GRADING EROSION CONTROL PLANS

FUEL STATION #4335

FALCON, CO

Sheet List Table		
		Sheet Title
1	OF 11	GRADING EROSION CONTROL COVER SHEET
2	OF 11	GRADING PLAN
3	OF 11	GRADING & EROSION CONTROL NOTES
4	OF 11	SWPPP NOTES
5	OF 11	SWPPP IMPLEMENTATION SEQUENCE
6	OF 11	PHASE I EROSION AND SEDIMENTATION CONTROL PLAN
7	OF 11	PHASE II EROSION AND SEDIMENTATION CONTROL PLAN
8	OF 11	SWPPP IMPLEMENTATION SUMMARIES
9	OF 11	SWPPP DETAIL SHEET 1
10	OF 11	SWPPP DETAIL SHEET 2
11	OF 11	SWPPP DETAIL SHEET 3

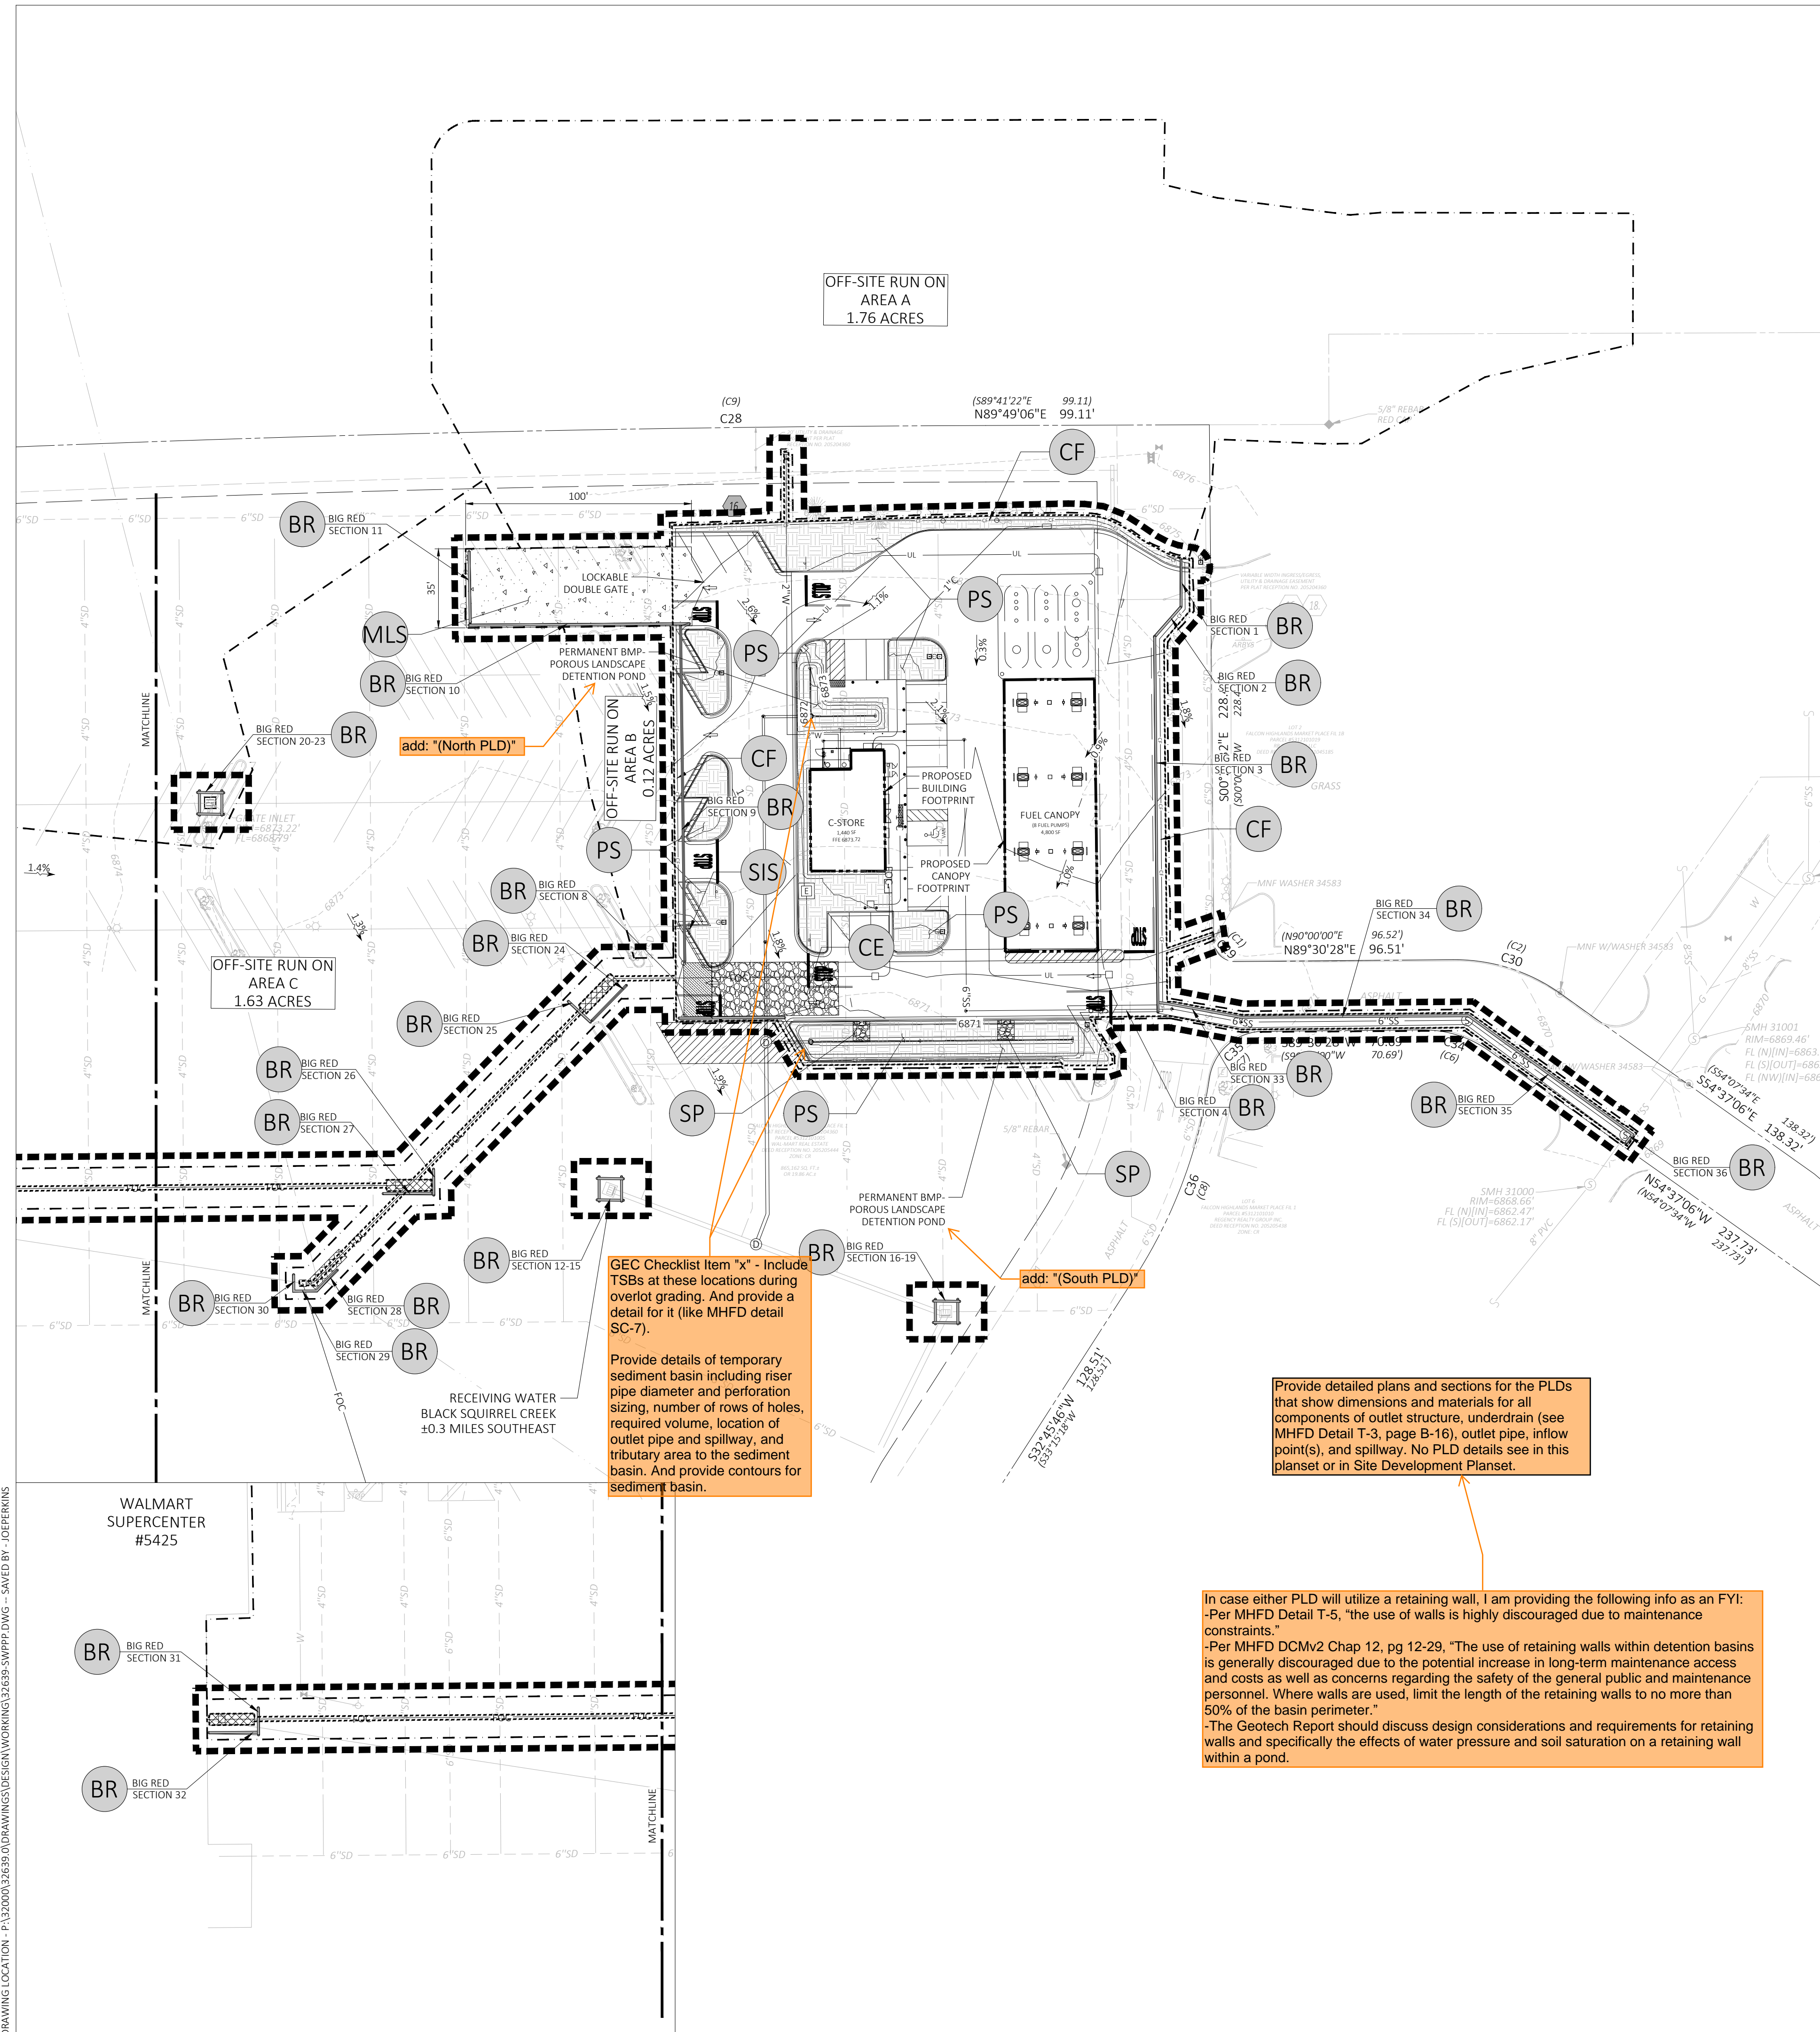
GEC Checklist Item "x" - Include TSBS at these locations during overlot grading. And provide a detail for it (like MHFD detail SC-7).  
Provide details of temporary sediment basin including riser pipe diameter and perforation sizing, number of rows of holes, required volume, location of outlet pipe and spillway, and tributary area to the sediment basin. And provide contours for sediment basin.

Provide detailed plans and sections for the PLDs that show dimensions and materials for all components of outlet structure, underdrain (see MHFD Detail T-3, page B-16), outlet pipe, inflow point(s), and spillway. No PLD details see in this planset or in Site Development Planset.

In case either PLD will utilize a retaining wall, I am providing the following info as an FYI:  
-Per MHFD Detail T-5, "the use of walls is highly discouraged due to maintenance constraints."  
-Per MHFD DCMv2 Chap 12, pg 12-29, "The use of retaining walls within detention basins is generally discouraged due to the potential increase in long-term maintenance access and costs as well as concerns regarding the safety of the general public and maintenance personnel. Where walls are used, limit the length of the retaining walls to no more than 50% of the basin perimeter."  
-The Geotech Report should discuss design considerations and requirements for retaining walls and specifically the effects of water pressure and soil saturation on a retaining wall within a pond.
